**Re:** Major Comprehensive Plan Application

Salem Harbor Redevelopment (SHR) Project (Transmittal Number X254064)

**Additional Information**

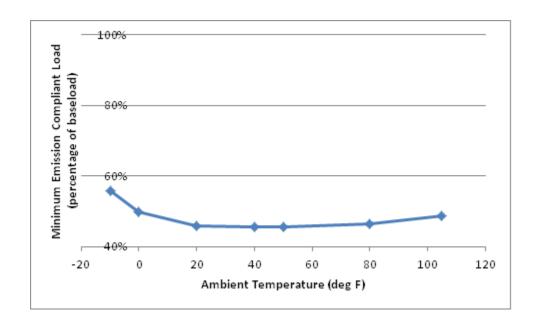
# (7) GE load range for emissions guarantees

GE has guaranteed compliance with emission limits over a CT load range from "MECL" to Peak firing conditions. MECL as a function of ambient temperature is shown below.
